Addendum 1

Site Revision and Answers to Participant Questions

Designing the Threshold

Issued September 28, 2026

ADDENDUM 1 · FIGURE 1

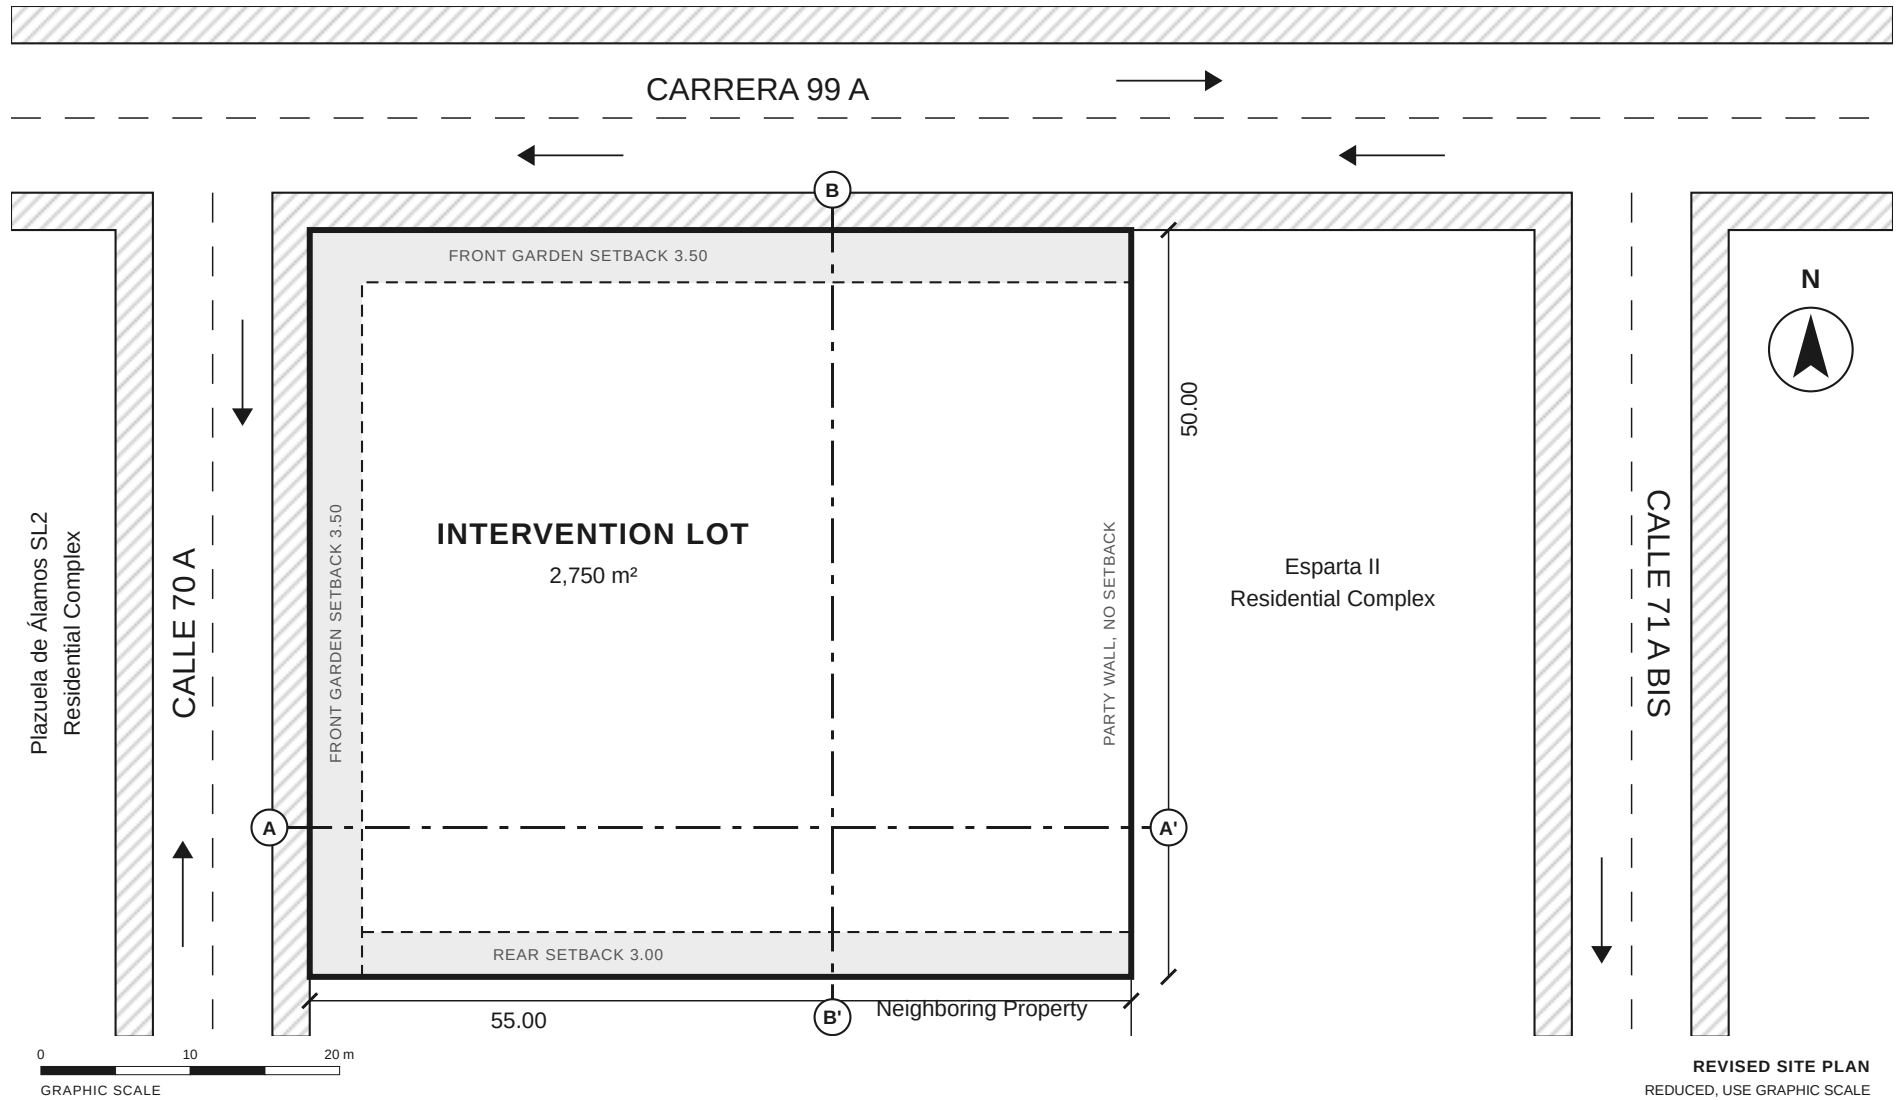
The intervention lot is now a 55.00 x 50.00 m rectangle with an area of **2,750 m²**. It replaces the irregular 2,683 m² lot described in the booklet. The lot was regularized to simplify the exercise; its location and surroundings are unchanged.

Edge	Faces
North (55.00 m)	Carrera 99 A (street)
West (50.00 m)	Calle 70 A (street)
East (50.00 m)	Esparta II Residential Complex (shared property line; may be built to the line)
South (55.00 m)	Neighboring property (shared property line; 3.00 m rear setback)

This is a corner lot with two street frontages and two shared property lines. **A 3.50 m front garden setback (antejardín) applies along both street frontages**, Carrera 99 A and Calle 70 A. Carrera 99 A is treated as the front of the lot, so the south edge is the rear and carries a 3.00 m rear setback; the east edge is a side and may be built to the property line. The front gardens must remain open and unfenced as part of the street; any secure boundary for the school must sit behind them, and they do not count toward the outdoor recreation area. Use the revised site plan issued with this addendum; it replaces the site plan in the booklet and the submission sheet template. All figures in the booklet that cite the old lot area or dimensions should be read against the new lot.

REVISED SITE PLAN: 55.00 x 50.00 m LOT (2,750 m²) WITH SETBACKS. REPLACES THE SITE PLANS IN THE REVISED BOOKLET AND ON SHEET 2 OF THE SUBMISSION TEMPLATE.
